Amendment proposals on FCHV

GTR15
AMD#5

prepared by JAPAN

31st August, 2018

Figure A8.App7/1
Example of instrumentation

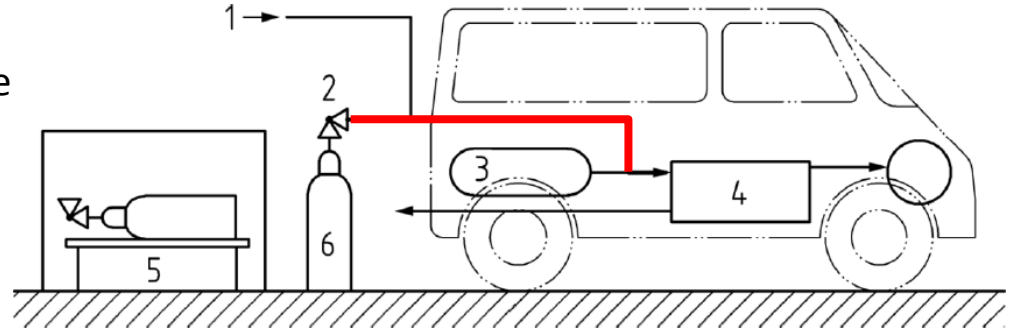
PROPOSAL : in case of gravimetric method, correction of non-consumed Hydrogen **in red line** should be allowed to obtain more accurate results. This correction can be done with either actual measurement or calculation (**density * length * inner diameter**)

Justification : pressure and temperature inside the hydrogen tank differ before and after testing. This causes weight difference in red line which is not reflected to weight change of hydrogen tank during testing.
